# UNITED STATES PATENT AND TRADEMARK OFFICE

APPLICATION NO.	FILING DATE	FIRST NAMED INVENTOR	ATTORNEY DOCKET NO.	CONFIRMATION NO.
10/644,470	08/20/2003	Elizabeth Chelsea Teich		5957

<b>Office Action Summary</b>	<b>Application No.</b> 10/644,470	<b>Applicant(s)</b> TEICH ET AL.	
	<b>Examiner</b> Carolyn T Blake	<b>Art Unit</b> 3724

**Figure 3b** from US patent 3,121,951 to Green. Drawing rotated by the examiner.

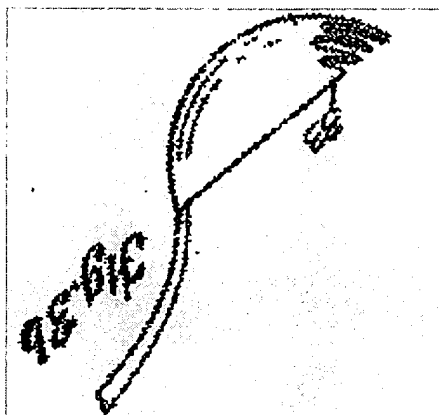
Regarding claims 8 and 9, the closed concave combined blade and scoop structure (13) extends downward and substantially perpendicular in a downward curvature from a longitudinally extending axis of the handle (11).

12. Applicant's remarks filed September 23, 2004 have been fully considered but are not persuasive. Applicant contends that the Green device would not be capable of scooping a bagel. This is incorrect; the references anticipate the claimed invention and the Green device would be capable of scooping a bagel. Applicant argues that the teeth disclosed by Green are too fine to go through the bagel dough. However, Green discloses several embodiments of teeth with various degrees of thickness. The teeth disclosed in FIGS 4 and 7 are very similar to those of applicant, and thus the Green teeth would perform equally well at scooping the bagel. In addition, applicant contends that the bowl of the Green device is upwardly facing, not downwardly facing. If the device were rotated at angle such as the one shown below, the scoop would be downward facing. Applicant further contends that the serrated teeth of the Green device are not suitable for scooping a delicate bagel wall. However, it is noted applicant's device includes serrated teeth (3b), and therefore, it would appear the Green device would be capable of scooping a bagel as well as applicant's device.
